LAKE WALTER DAM

3 NDI I.D. PA-0080

7 PHASE I INSPECTION REPORT

D'APOLONIA CONSULTING ENGINEERS
10 DUFF ROAD
PITTSBURGH, PA. 15235

PLATE 5
 LAKE WALTER
 GENERAL PLAN
 FIELD INSPECTION NOTES
 FIELD INSPECTION DATE: NOV. 13, 1980

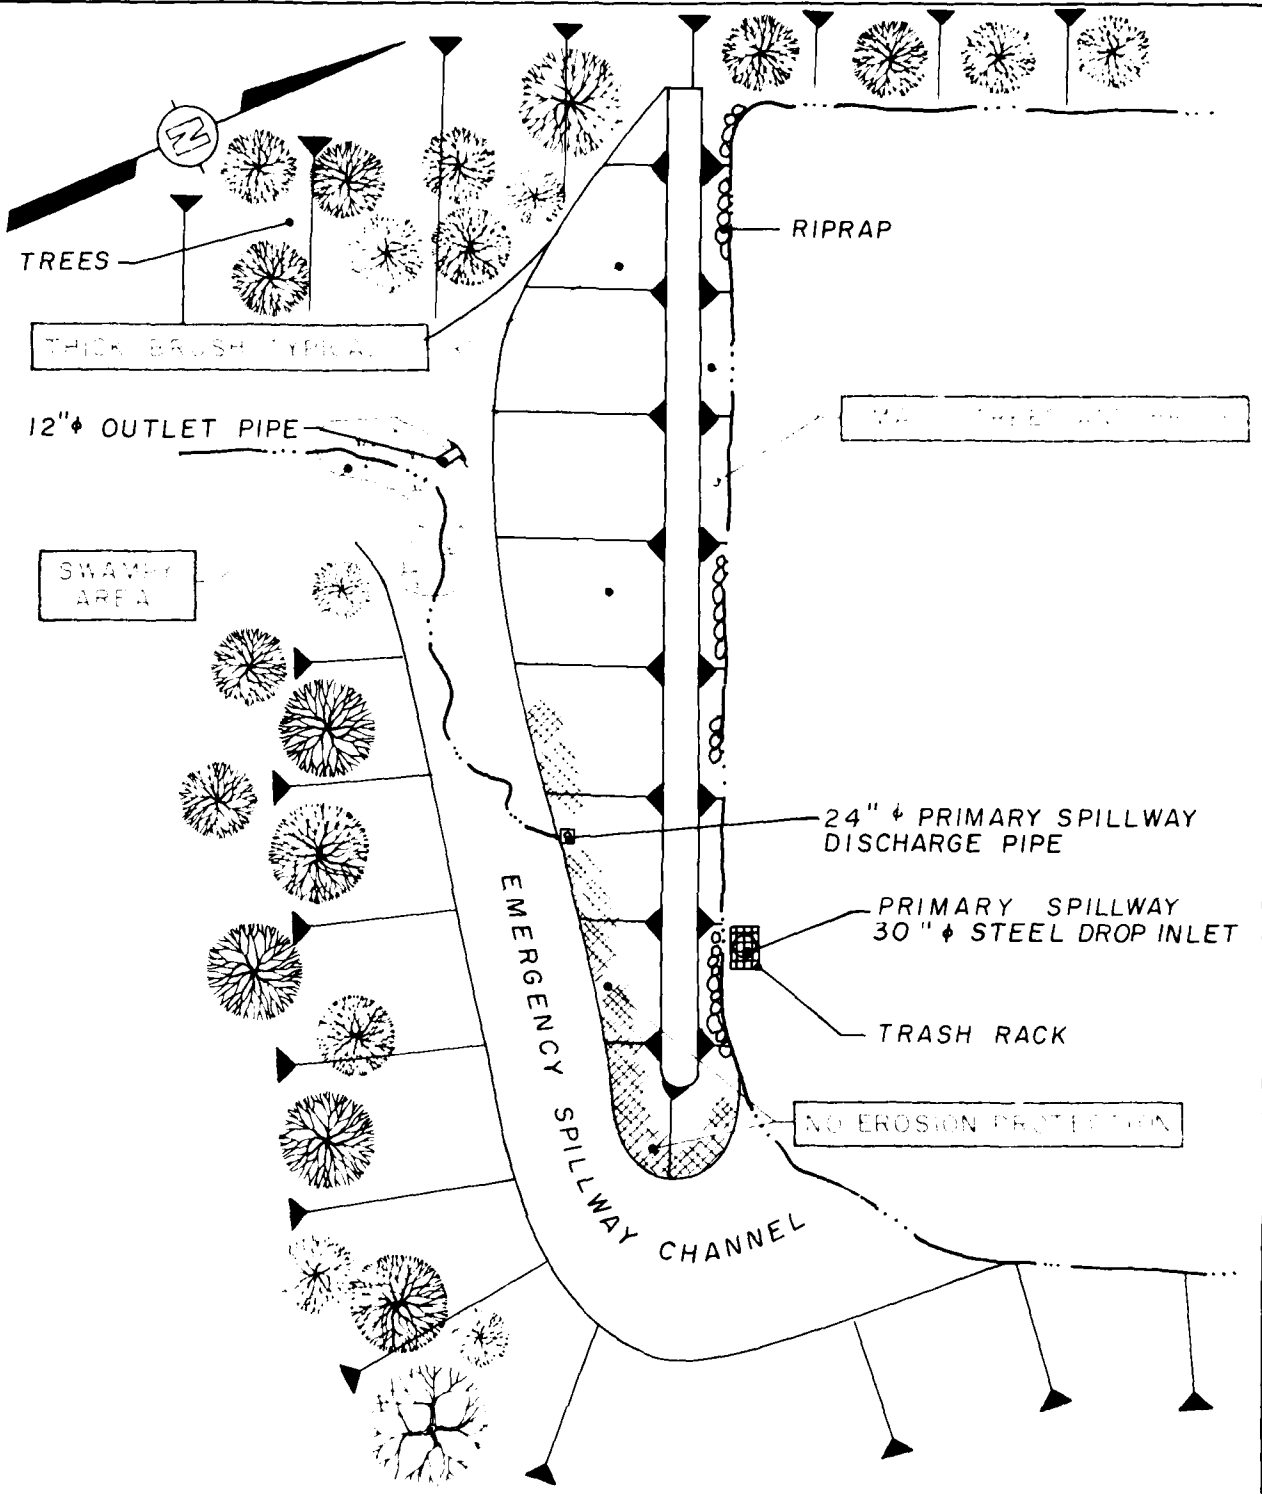
The specific observations are illustrated in Plate 5.

In general, the condition of the dam is considered to be good. One wet area was observed at the toe of the dam near the outlet pipe. No seepage flow appeared to be associated with this area. The downstream face of the dam was covered with thick brush which precluded adequate inspection of the dam.

DAM CREST PROFILE
(LOOKING DOWNSTREAM)

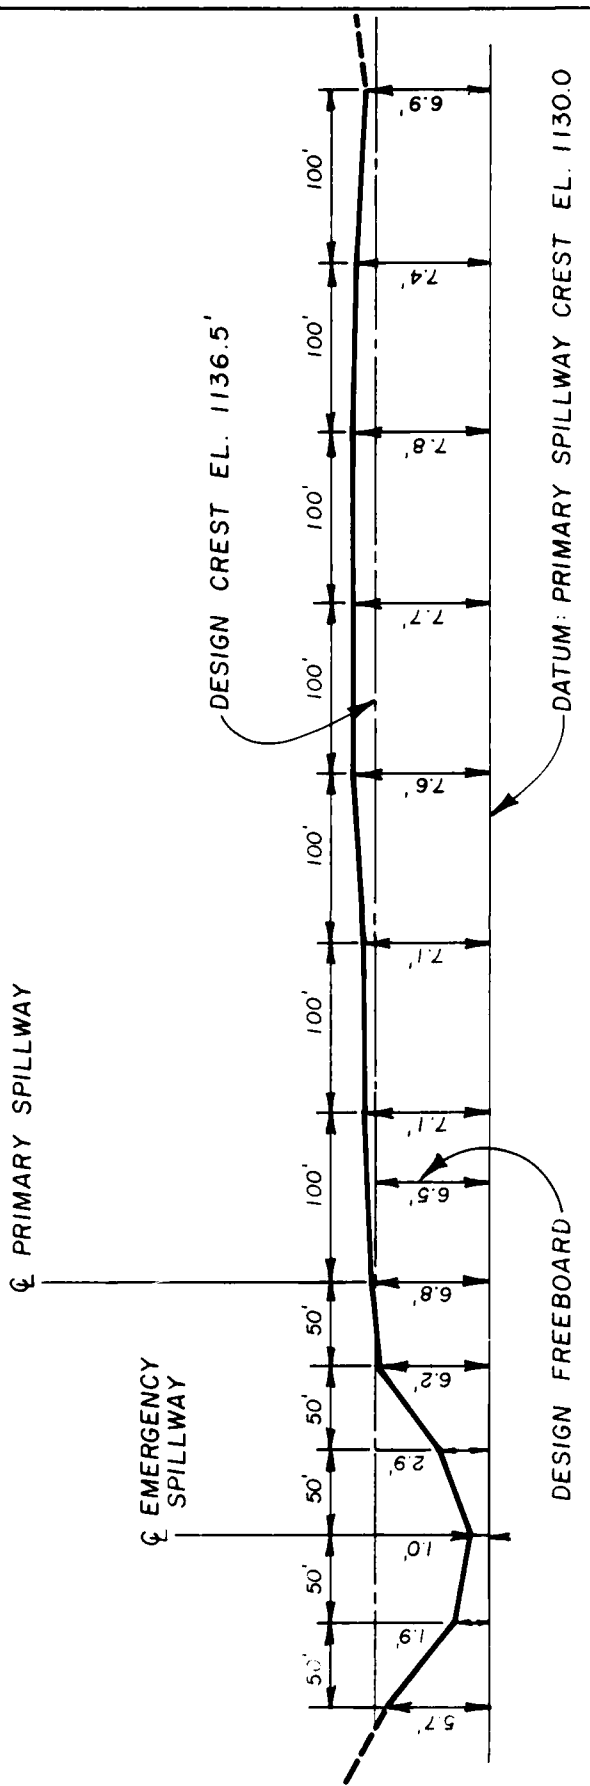
The top of the dam was surveyed relative to the spillway crest elevation and was found to have some vertical irregularities. Although the design freeboard for the dam is 6.5 feet, the field survey indicated freeboards ranging from 6.8 feet to 7.8 feet. The lowest area occurred in a section adjacent to the emergency spillway. The dam crest profile according to field measurements is illustrated in Plate 6.
